Technical Bulletin

R4 ROADWARRIOR™ PLATFORM Post & Rail System

FM-7.5-71
Rev A
10-01-09

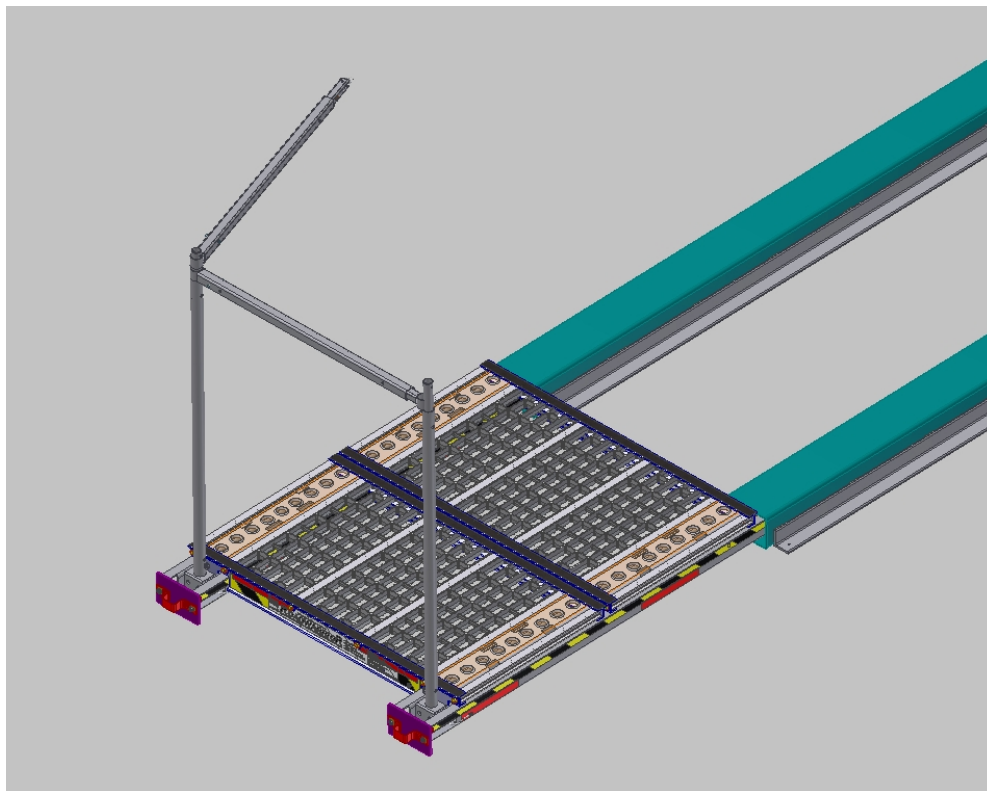
The ITF and rising R4 Roadwarrior Platforms now have a storable post and rail to replace the folding post and chain. The system consists of two posts and two rails. On the ITF version, each post is tethered to its girder by way of a wire rope, so it cannot be misplaced. The posts and rail store in the middle of the girder. One rail fits over the ends of the posts, while the other rail fits between one post and the trailer wall. The new design will be on units ordered after early October 2009.

The new girders fit into the tubes like the earlier version.
